COMMUNITY ROOTS  
HOUSING

DESIGN  
RECOMMENDATION  
SUBMITTAL

1323 EAST UNION STREET  
PROJECT # 3035728-LU

Community Roots Housing  
Administrative Design Recommendation RESPONSE  
1323 E. Union Street

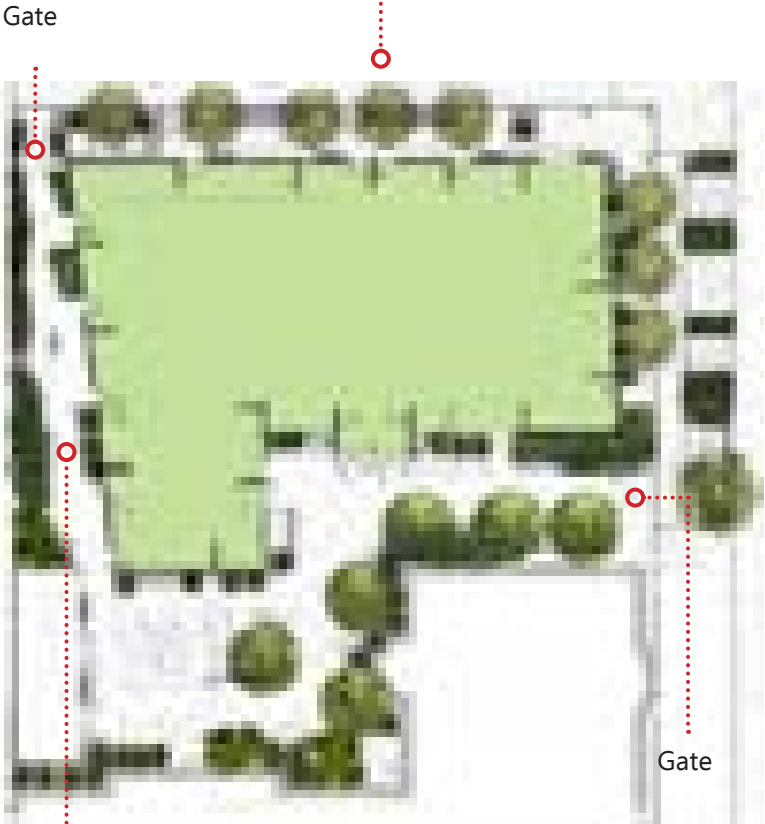
1. 1. MASSING AND CONFIGURATION  
Modulation in the upper levels of the preferred massing will be prominently visible as the site is located at a major intersection within the neighborhood. Echoing public comment, Staff recommends breaking up the perceived bulk of the upper level massing through strategic application of the material palette and the use of secondary architectural elements.

**RESPONSE**  
The strong and simple massing marks the prominent corner in a modest and restrained way. The building’s massing takes its cues from the unassuming, simple shapes of its two 100-year-old neighbors: the Helen V and the Texada Apartments, both clad in dark brick, and also the six-story 1310 E Union building across the street, clad in dark gray fiber-cement material.

By using clear and intelligible massing that reflects the clear massing of its neighbors, the building relates to the surroundings and the community in simple and direct ways, per Design Guideline DC2.1.a. Also, Design Guideline DC2.1.b recommends that the building meet the street level in a pedestrian-oriented way with human-scaled materials. The building meets this requirement by utilizing the warm wood colors of the cladding at the ground floor, delineation of the upper massing from the ground level, and the scale of the unit entryways.

Design Guideline DC4.2.a is met in the upper stories, using strong, dark materials with brightly contrasting wood-toned elements at the windows. The rhythm of the windows brings a visual interest and modulation in ways that intrigue the eye and break up the façade on E. Union St, per DC4.3.b,d. Finally, both prominent corners of the building, at 14th Ave and E. Union St., and at E. Union St. and the west easement, are marked vertically with larger windows, allowing these two important corners of the building to glow at night and open up generous territorial views from the units inside, per DC4.3.d. Please see preliminary draft renderings.

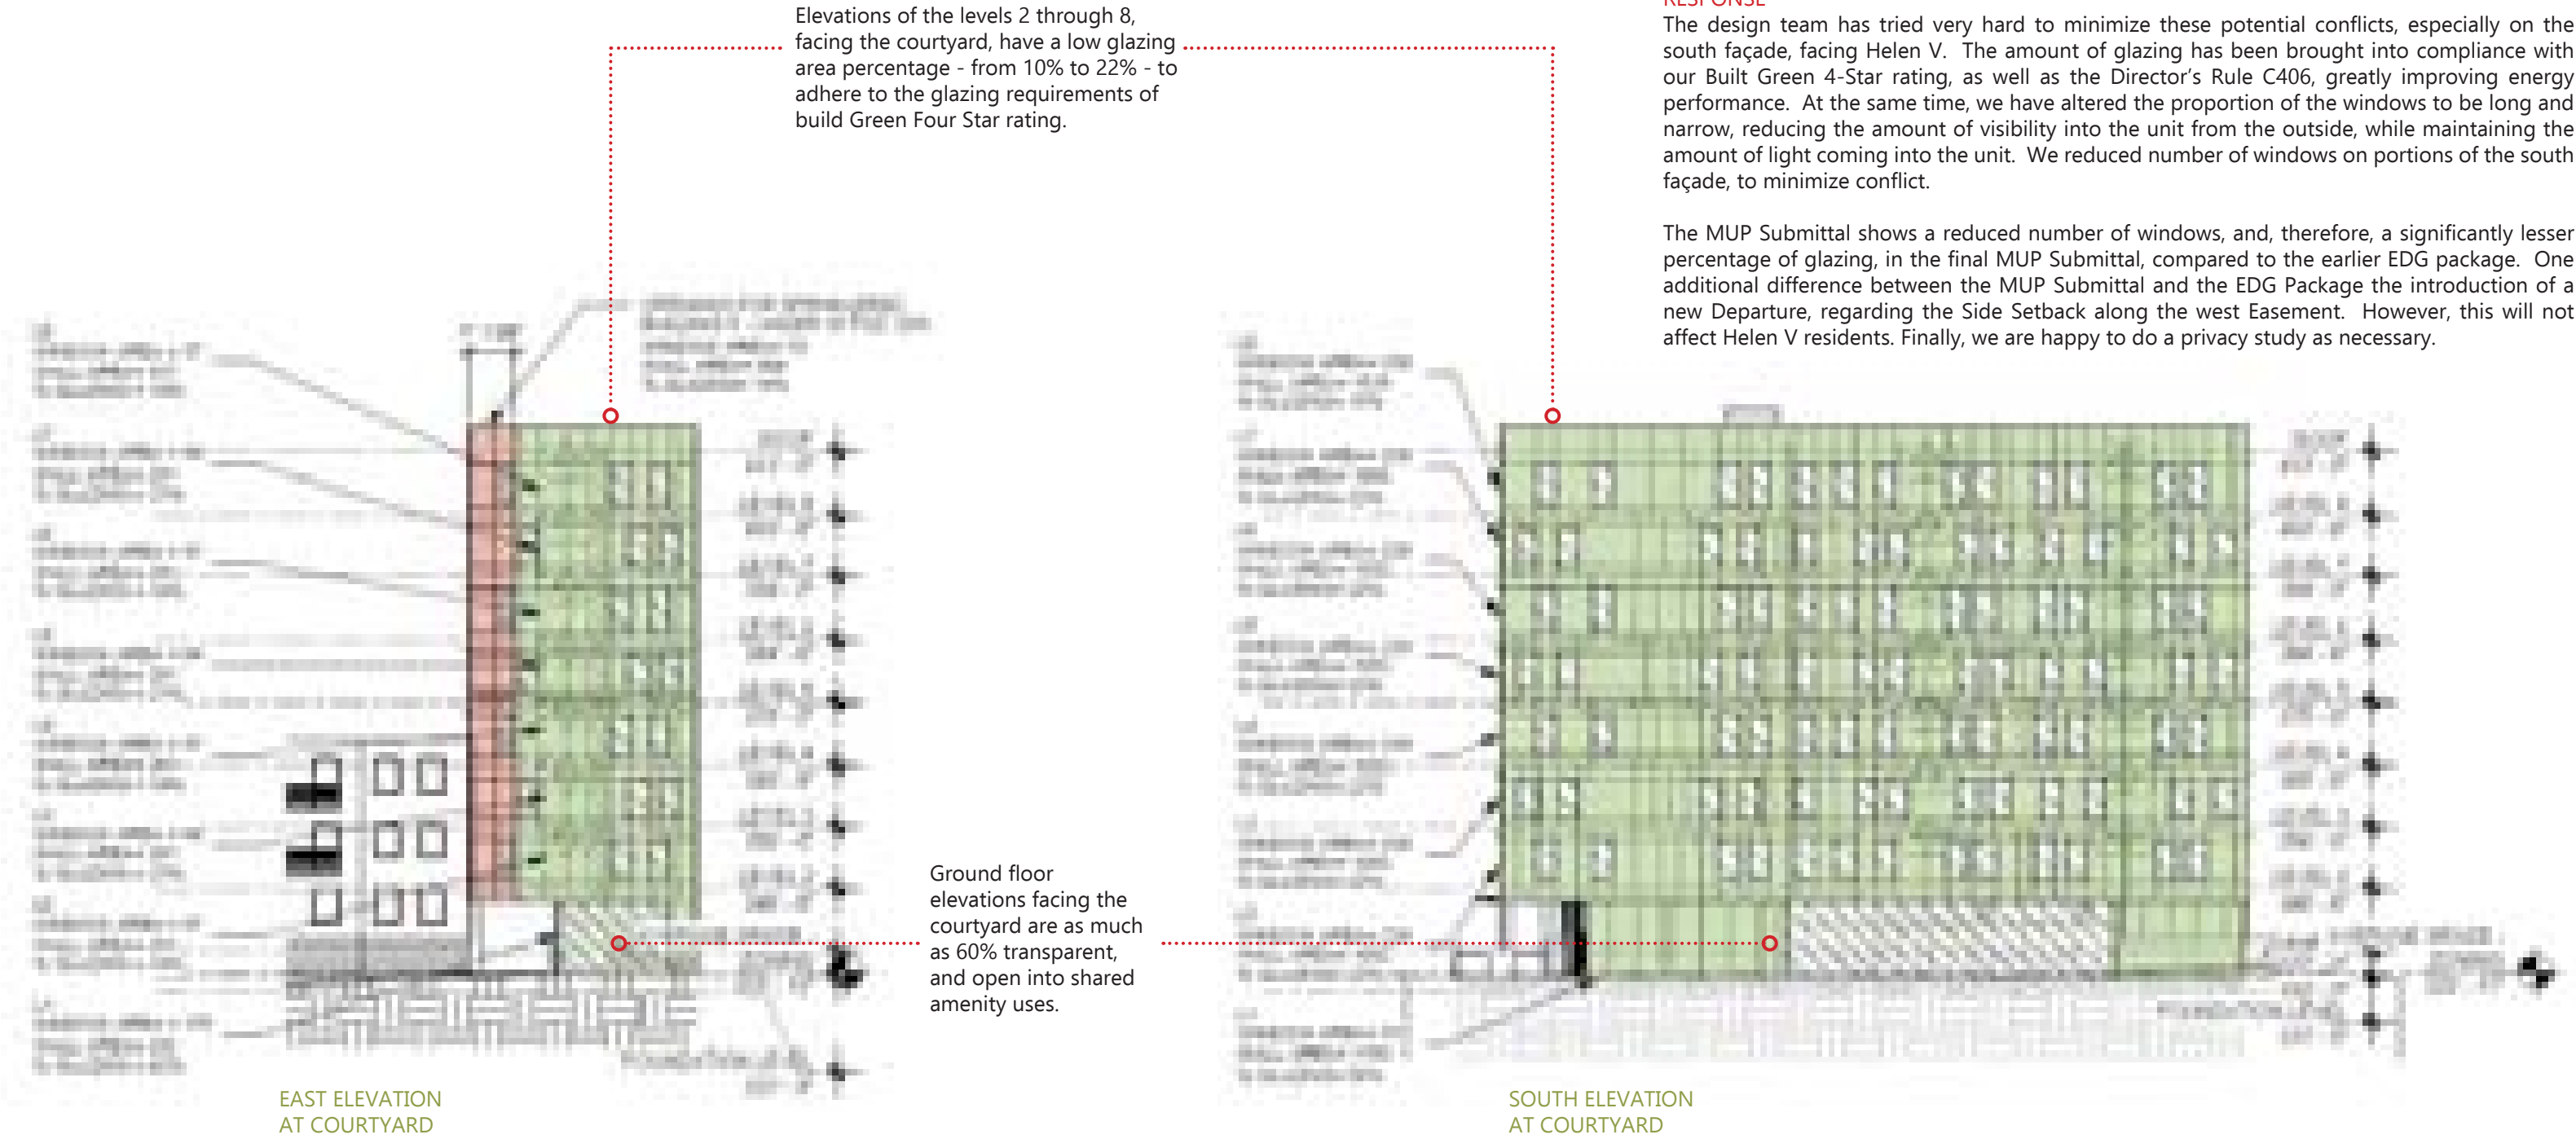
There is a concern regarding potential privacy issues with residents in the adjacent Helen V apartment building. In developing the façades, fenestration should minimize overlap with the existing apartment building. A privacy study shall be provided at recommendation.

The design team has tried very hard to minimize these potential conflicts, especially on the south façade, facing Helen V. The amount of glazing has been brought into compliance with our Built Green 4-Star rating, as well as the Director’s Rule C406, greatly improving energy performance. At the same time, we have altered the proportion of the windows to be long and narrow, reducing the amount of visibility into the unit from the outside, while maintaining the amount of light coming into the unit. We reduced number of windows on portions of the south façade, to minimize conflict.

The MUP Submittal shows a reduced number of windows, and, therefore, a significantly lesser percentage of glazing, in the final MUP Submittal, compared to the earlier EDG package. One additional difference between the MUP Submittal and the EDG Package the introduction of a new Departure, regarding the Side Setback along the west Easement. However, this will not affect Helen V residents. Finally, we are happy to do a privacy study as necessary.

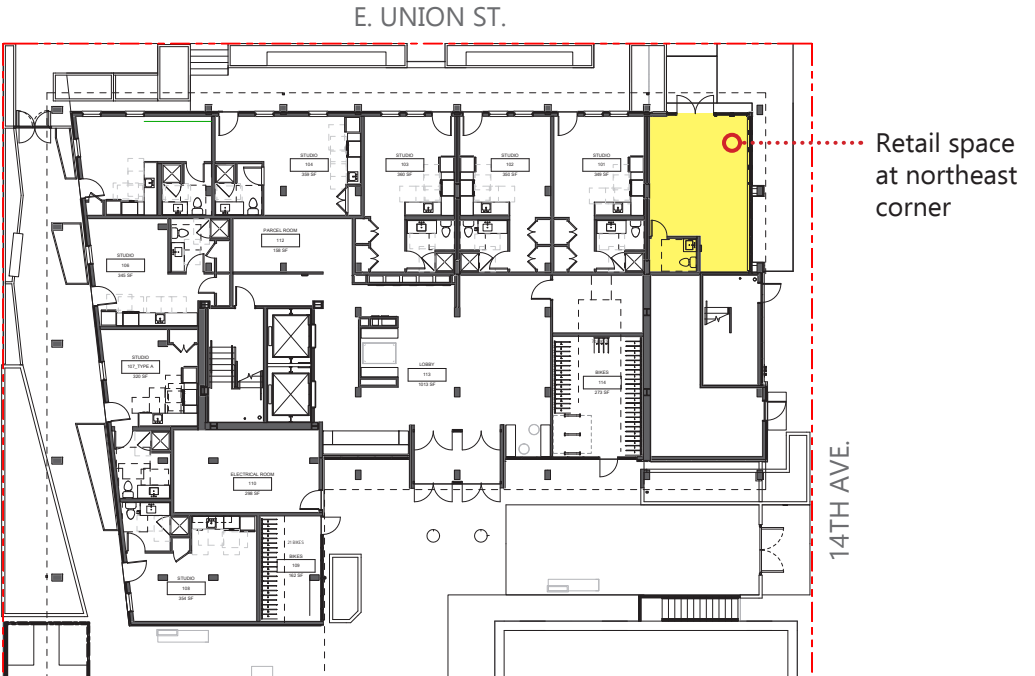
3.1 PRIMARY ENTRIES AND GROUND LEVEL USES  
The design of the commercial space should differ from that of the adjacent residential uses and have a distinct character. Recommendation is to provide ample glazing to increase visibility into the space from the public realm.

**RESPONSE**  
The project includes a small commercial space at the prominent corner of 14th Ave. and E. Union St. In order to differentiate the commercial space from the residential units next door, we designed it with Design Guidelines PL3.1.b,c,d and PL3.2.b,d in mind. The commercial space has a two-story tall interior, with significant storefront glazing on both E. Union St. and 14th Avenue. Working closely with the existing street grades, we designed the entry as level and accessible as possible.

Vertical blade signage, signs along the spandrel panels and over the door of the storefront along the 14th Ave. and Union St. facades are designed to provide as much identity for the commercial space as possible, ensuring its success. Additionally, a separate address will be implemented to focus the importance of the identity of the commercial use at the corner: while the apartment building is addressed 1323 E. Union St., the retail space will be 1321 E. Union St.

Two-story interior height and the transparency of the facade differentiate the retail space at the prominent corner of E. Union St. and 14th Ave.

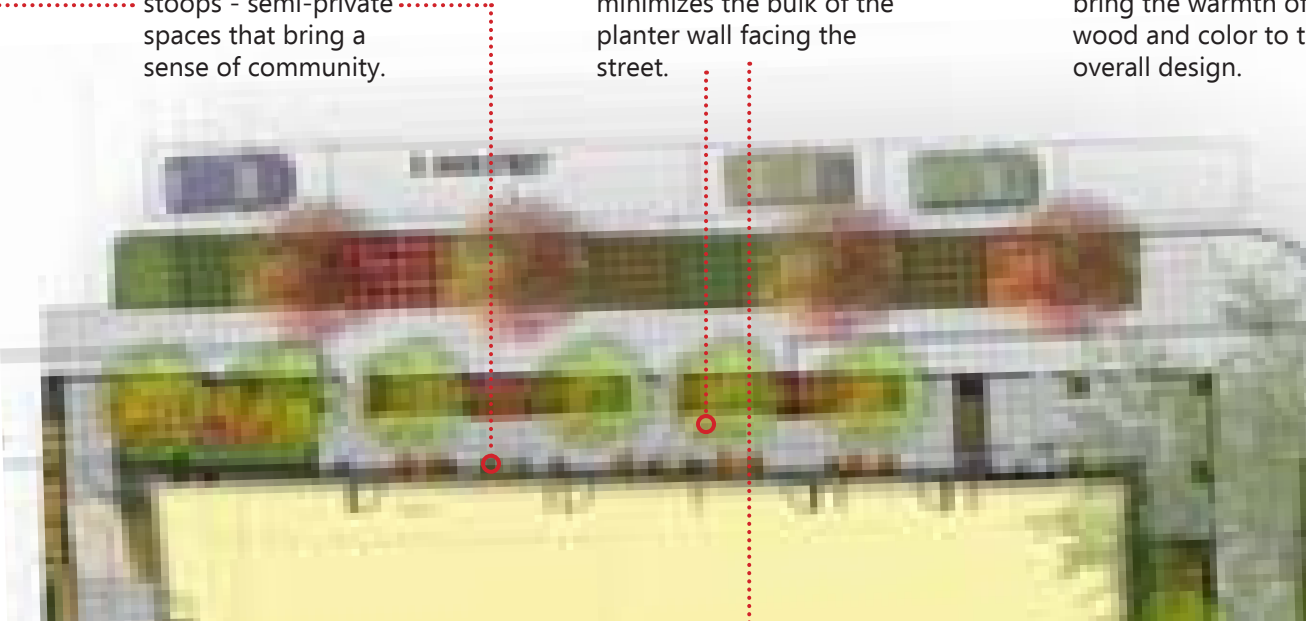
3.3 PRIMARY ENTRIES AND GROUND LEVEL USES  
At the individual ground level residential entries along E. Union Street and the easement, minimize the appearance of blank wall due to changes in the topography by incorporating landscaping and other design elements such as lighting and signage for the entries along E. Union Street and the easement/alley.

**RESPONSE**  
Following Design Guidelines CS2.1.d, and PL1.1.d, the project strives to create great pedestrian spaces, a lively streetscape, defensible unit entries, and usable residential exterior spaces. Working with the grades along Union, we have created stoops that gather two or three units together, producing a few small, semi-private spaces, which bring a sense of community to the units on Union. Same strategy creates a larger, more connected semi-private space for the residential units off of the easement. The almost level entry off of Union at the easement, under the sheltering building overhang, creates a welcoming secondary entry to the Helen V project and our building, for use by all inhabitants.

Pairs of units create stoops - semi-private spaces that bring a sense of community.

Generous landscaping minimizes the bulk of the planter wall facing the street.

Signage and lighting bring the warmth of wood and color to the overall design.

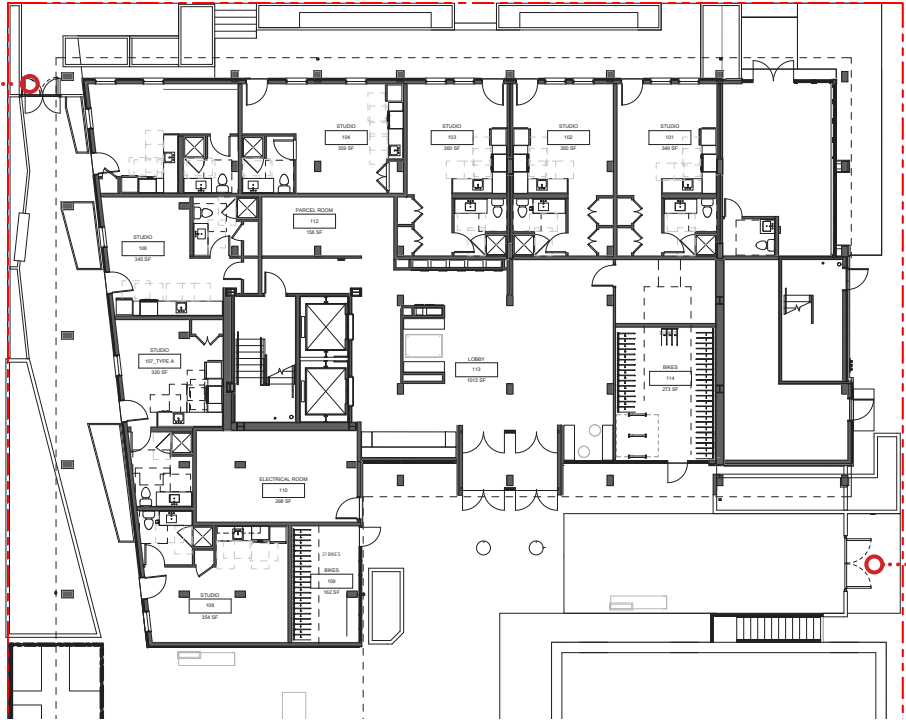
4.2 COURTYARD AMENITY AREA  
Staff is concerned with the number of entry gates proposed along 14th Avenue and recommends reconfiguring the design to have a singular entrance and high level of permeability to allow for visual connections to the neighborhood.

**RESPONSE**  
To create a sense of security without being overly defensive, a single four-foot-high pedestrian gate is designed at the entry into the arcade walkway of off E. Union St., and slightly larger gates are placed at the main entry off of 14th Ave. Solid waste will be transferred in and out onto 14th Avenue, so that the large double gate at the main entry would need to open, and also be available for daily use by residents of the buildings. Gates and any fencing will be visually permeable and appear as transparent as possible to encourage openness between the courtyard and the street.

4' 0" tall pedestrian gate: entry from E. Union Street

View of the courtyard from 14th Ave.

A larger gate provides a single entry from 14th Avenue to both Helen V and the new proposed building. This gate also serves to move the solid waste containers to the staging area on 14th Avenue.
